Building 1208 - ENLISTED MEN'S BARRACKS

STRUCTURAL EVALUATION

REHABILITATION GUIDELINES BUILDING 1208
 PRESIDIO OF SAN FRANCISCO
 NPS CX-2000-0-0030 W.O. 14

BASEMENT PLAN

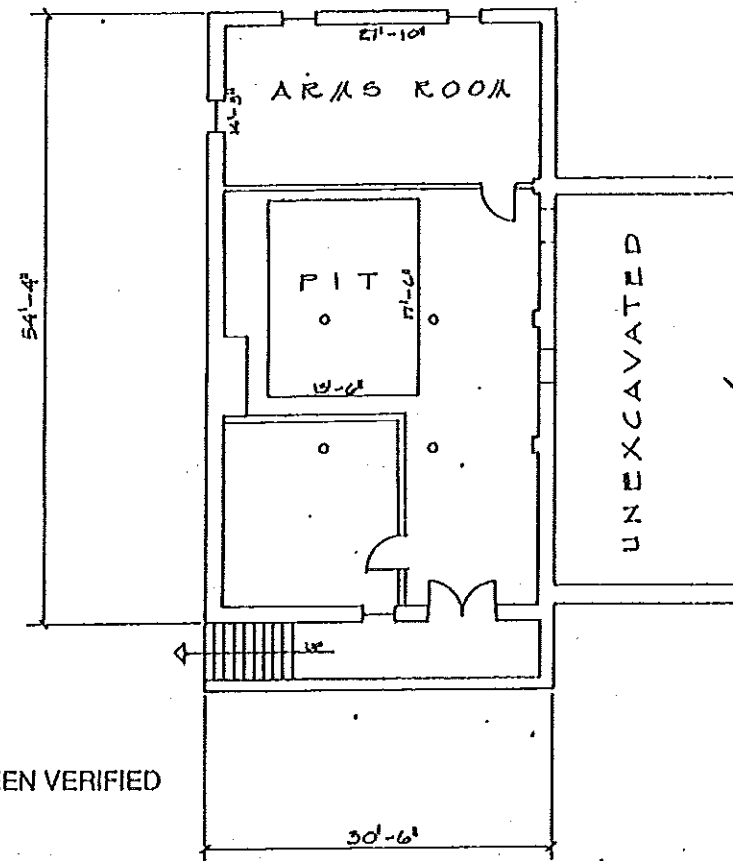
<i>Exterior</i>	<i>Interior</i>	<i>Life Safety/Egress</i>	<i>Disabled Access</i>	<i>Mechanical/Electrical</i>
4140 Broken mullions, wood deteriorated on exterior window. Replace sash with new to match existing.	4210 Efflorescence, broken and cracked plaster wall in basement. Patch damaged plaster and paint.	None Noted.	None Noted.	None Noted.

FIRST FLOOR PLAN

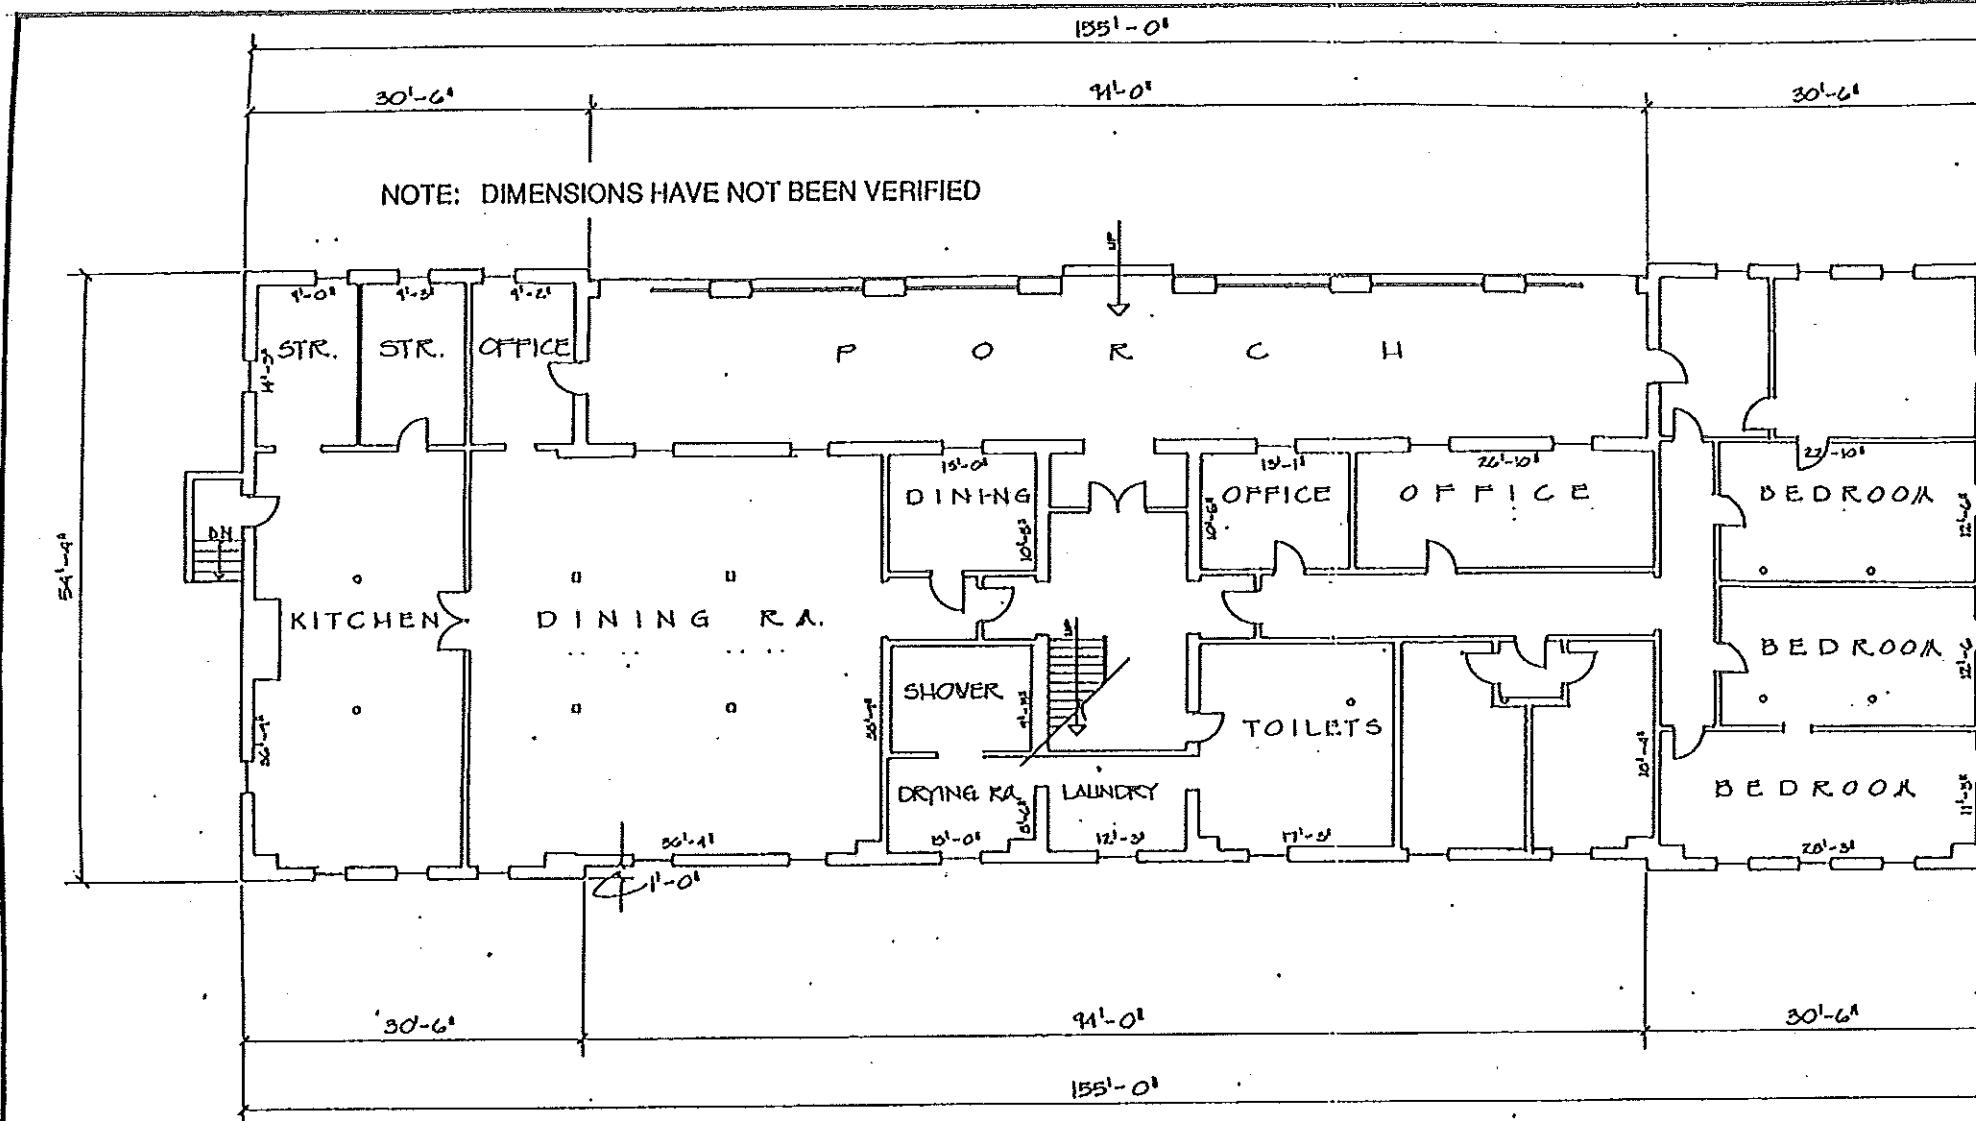
- 4110 Broken clay tiles on exterior wall. Replace with new clay tiles to match existing.
- 4131 Spalling and cracks in concrete porch floor. Patch spalling and cracks.

- 4244 Transom glass is painted over. Remove paint from glass.
- 4253 Trim is missing. Install new trim in historic style.

- 4133 Exterior guardrails too low; openings between rails too large. Install new guardrail behind existing; new guardrail to be 1 pipe rail and wire mesh.
- 4254 Interior doors have non-safety glass in hazardous location. Reglaze with safety glass.
- 4273 Stair handrail is too low and not grippable; guardrails are too low. Add new handrail at wall with returns; add rails at guardrail to achieve 42" height.
- 4711 No level landing at exterior side door. Install 44"x 60" landing at each door.

- 4712 No handrails on exterior stair. Install new metal handrails.
- 4712 There is a step at the door, handrail and guardrail are non-conforming, stairs too steep, open risers, guardrail missing. Replace entire stair.
- 4255 Knob hardware on interior doors is not code compliant. Replace with lever lockset hardware.
- 4713 Doors do not meet disabled access requirements. Install 36" wide door, patch wall to match adjacent finishes.

- 4771 No designated handicap parking. Provide striping, signage, curb cut for disabled parking space.
- 4772 No handicap access to door; no access to porch from grade. Install handicap accessible ramps and railings.
- 4772 No disabled access between floors. Install 3-stop elevator.
- 4773 Floor is 1" lower than corridor; 1/2" max. allowed for handicap accessibility. Flare flooring at 1:15 slope to corridor floor.

- 4774 No handicap accessible fixtures or accessories in restrooms. Rework to provide 1 disabled accessible wc, lavatory and accessories.
- 4775 Drinking fountain not handicap compliant. Replace with handicap compliant electric water coolers.

- 5026 No back flow prevention at hose bibbs. Install back flow prevention devices.
- 5074 No bird screen at kitchen exhaust. Install bird screen.

SECOND FLOOR PLAN

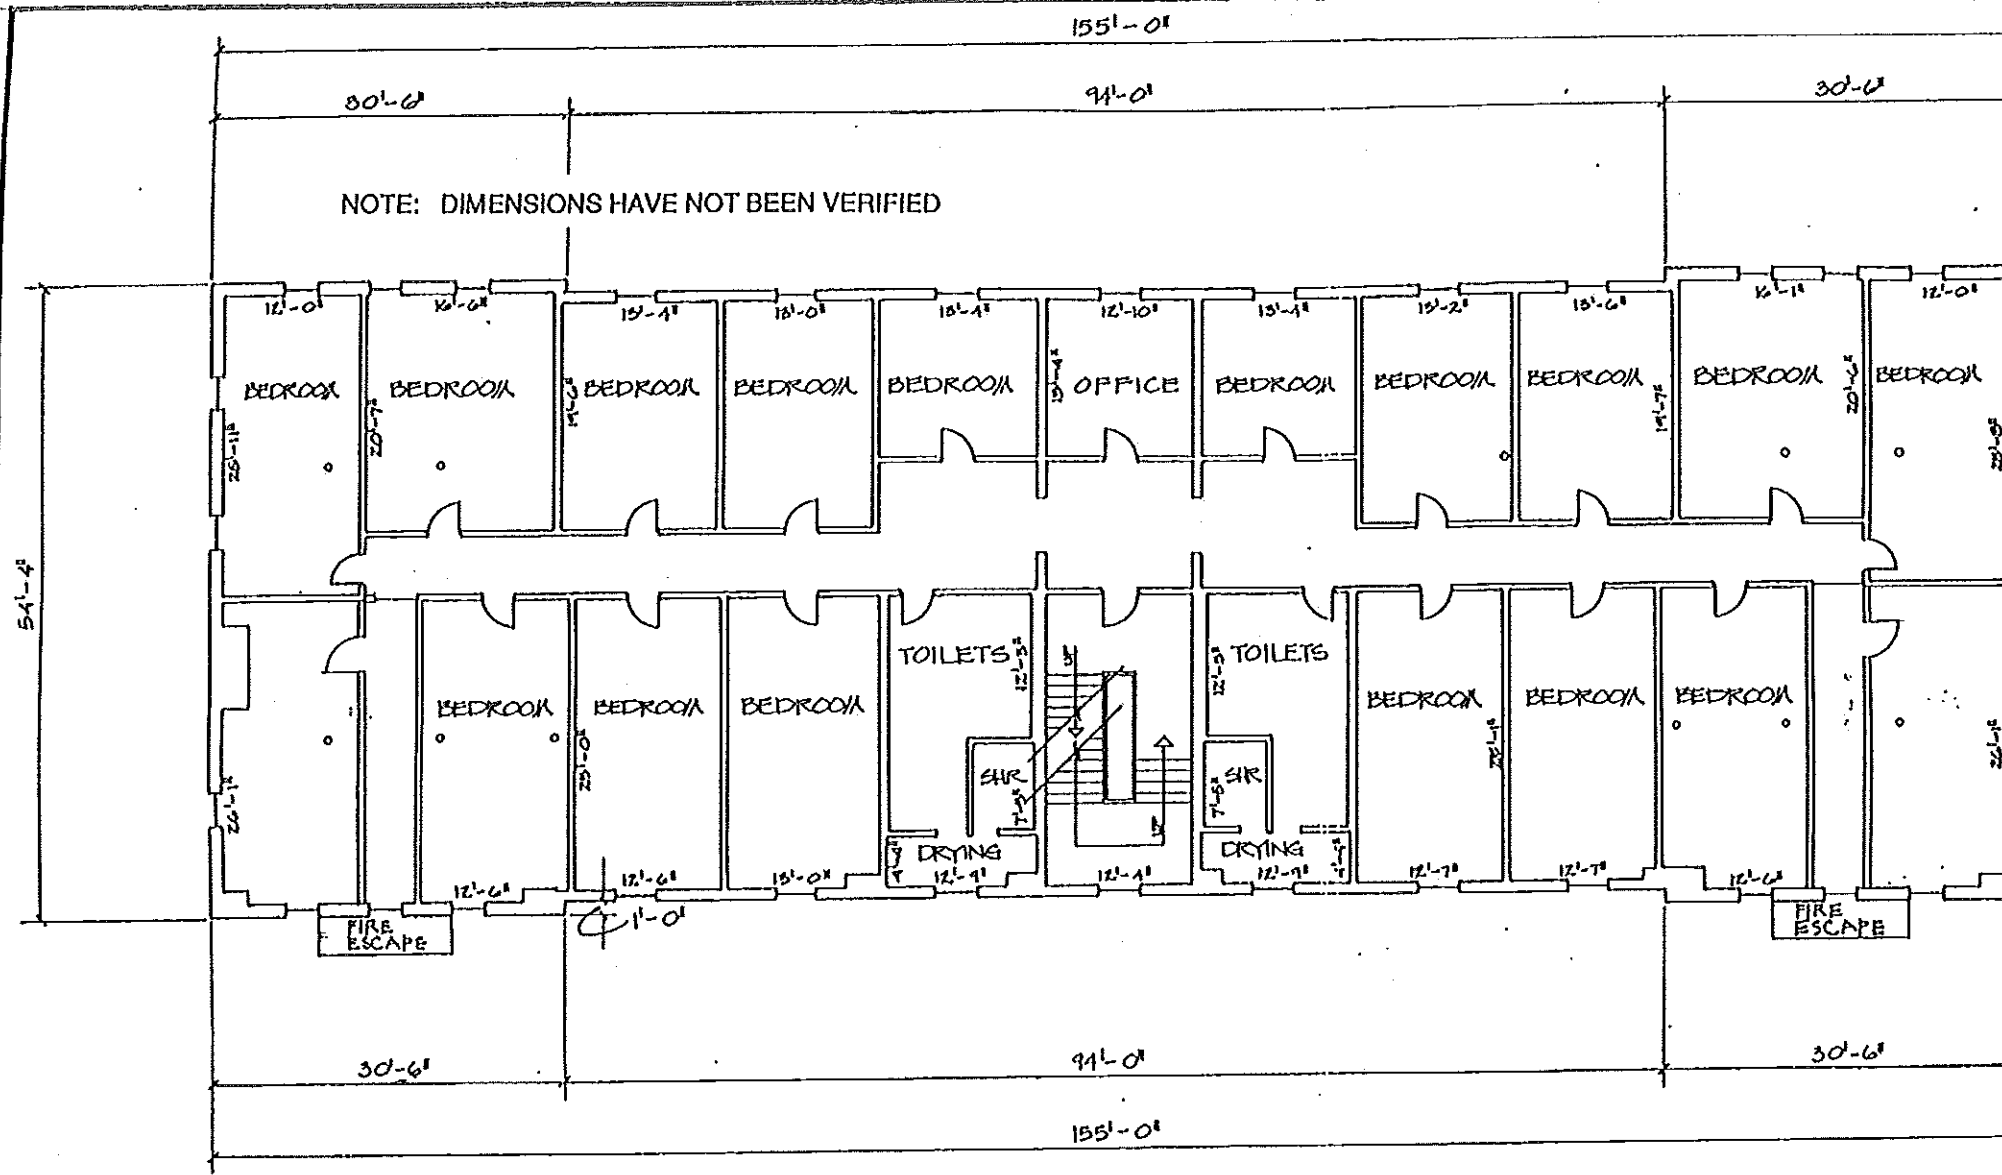
4213 Vinyl base is missing. Install new vinyl base.

4254 Interior doors have non-safety glass in hazardous location. Reglaze with safety glass.

4273 Stair handrail is too low and not grippable; guardrails are too low. Add new handrail at wall with returns; add rails at guardrail to achieve 42" height.

4711 No code compliant second means of egress from second floor or attic. Provide enclosed exit stairs at each end of building.

4255 Knob hardware on interior doors is not code compliant. Replace with lever lockset hardware.

4713 Doors do not meet disabled access requirements. Install 36" wide door, patch wall to match adjacent finishes.

4772 No disabled access between floors. Install 3-stop elevator.

4774 No handicap accessible fixtures or accessories in restrooms. Rework to provide 1 disabled accessible wc, lavatory and accessories.

4775 Drinking fountain not handicap compliant. Replace with handicap compliant electric water coolers.

ATTIC PLAN

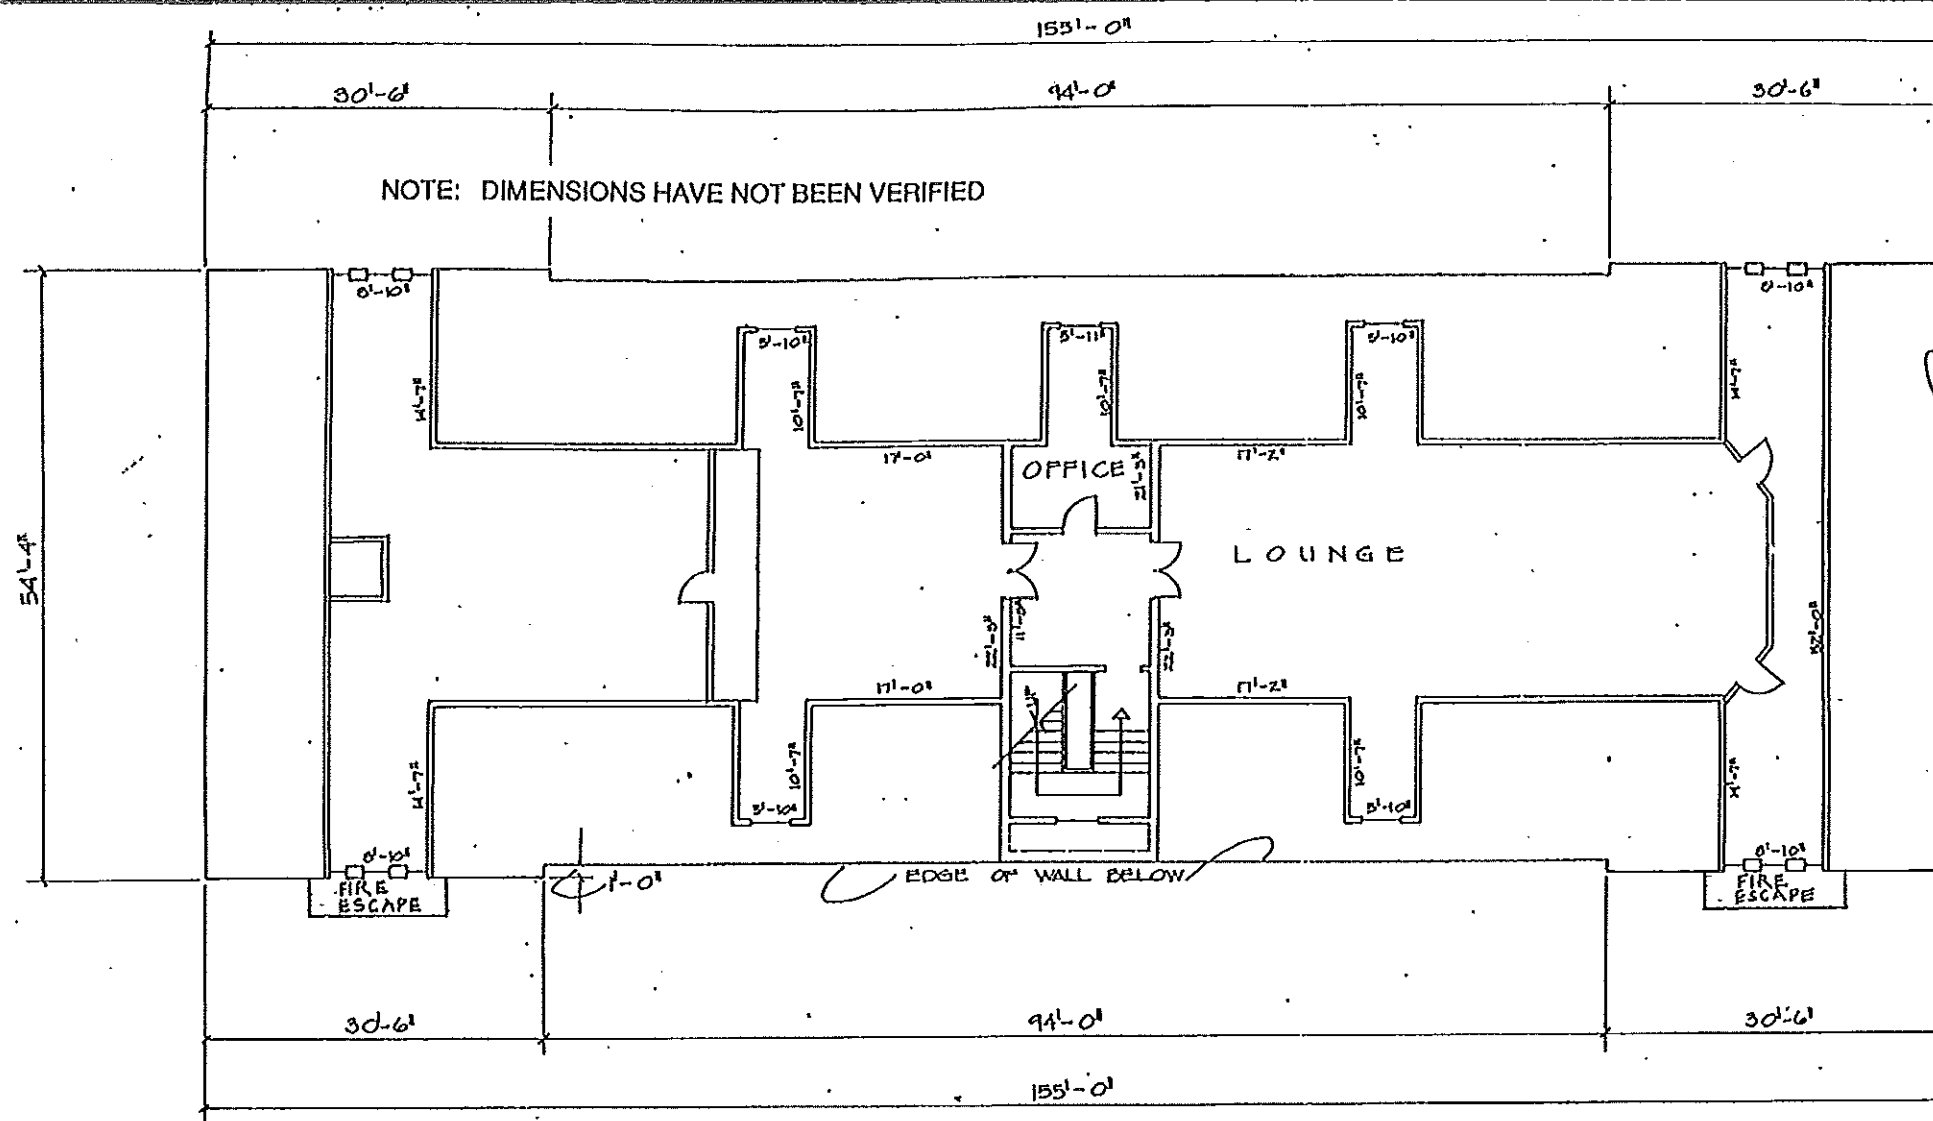
- 4142 Window sash is missing. Install new sash to match existing.
- 4144 Glass is painted over. Remove paint from glass.
- 4146 Wood window sill is deteriorated. Replace with new to match.

- 4254 Interior doors have non-safety glass in hazardous location. Replace with safety glass.

- 4273 Stair handrail is too low and not graspable; guardrails are too low. Add new handrail at wall with returns; add rails at guardrail to achieve 42" height.

- 4711 No code compliant second means of egress from second floor or attic. Provide enclosed exit stairs at each end of building.

- 4255 Knob hardware on interior doors is not code compliant. Replace with lever lockset hardware.

- 4713 Doors do not meet disabled access requirements. Install 36" wide door, patch wall to match adjacent finishes.
- 4772 No disabled access between floors. Install 3-stop elevator.

- 4773 8" platform/stage with no handicap access. Install wood ramp.
